Subject: Oulton Parish Council registration no: 20012656 deadline 8

### Oulton Parish Councils response at deadline 8 to applicants deadline 7 submissions

Noise mitigation Measures at The Old Railway Gatehouse Position Statement Issue Specific Hearing 6 action point 14,

Technical Note Responding to Norfolk County Council's Request for Trenchless Crossings of the A1067 and B1149

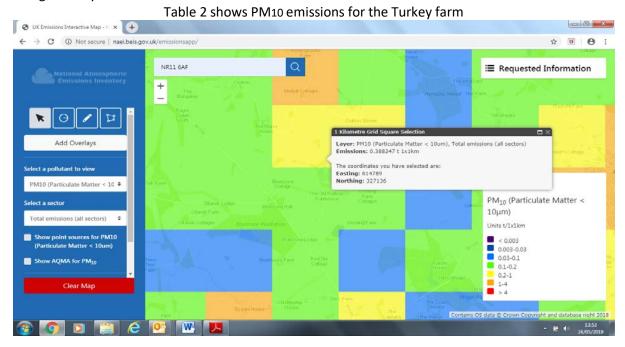
OPC would point out that the intensive turkey farm has a permit from the Environment Agency which monitors the annual discharge of PM10 and is subject to control of those emissions. The screen shot *Table 1* shows the Environment Agency permit information (*environment agency 'what's in your back yard'*) for emissions up to 2012......

OPC questions whether the levels of PM10 emissions from the intensive turkey farm, plus the addition of assessed cumulative traffic and dust from construction materials would be within the objective of annual PM10 40  $\mu$ g/m3?

#### **Trenching of B1149**

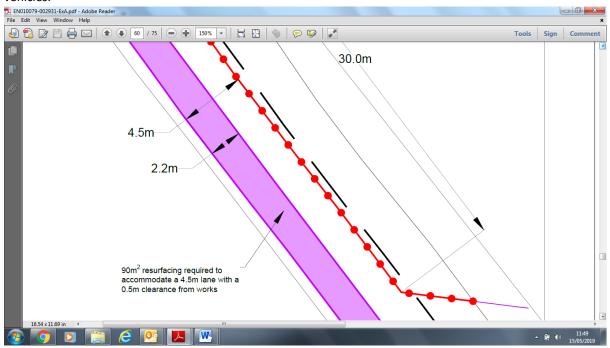
OPC note that the applicants propose to create a single lane width of 4.5m this is to accommodate abnormal loads. To achieve this 2.2m will be needed to widen the road. This appears to give 0.1m margin for error as the cable drums for HOW3 will be 4.4m wide; this also does not take into consideration large and wide agricultural vehicles.

Junction appears to be shown without the bellmouth modifications.

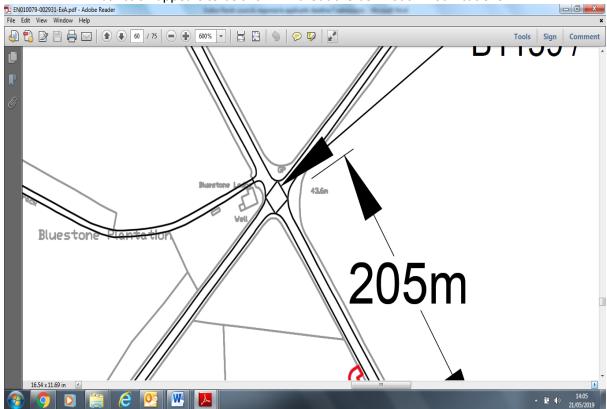
The road layout below shows that there will be 205m between the Junction B1149/The Street and the road works. OPC observe that the road intervention scheme widening of the junction will result in a reduced distance due to the Bellmouth entrance at the junction. It appears that the plan used

does not include the modifications. OPC also question whether the traffic works during trenching will result in tail backs at the junction and to the hump back bridge on B1149 especially if there are AIL arriving and departing from HOW3 Main Compound. OPC have already highlighted this issue in regard to the VISSIM modelling and the very real dangers this would present.
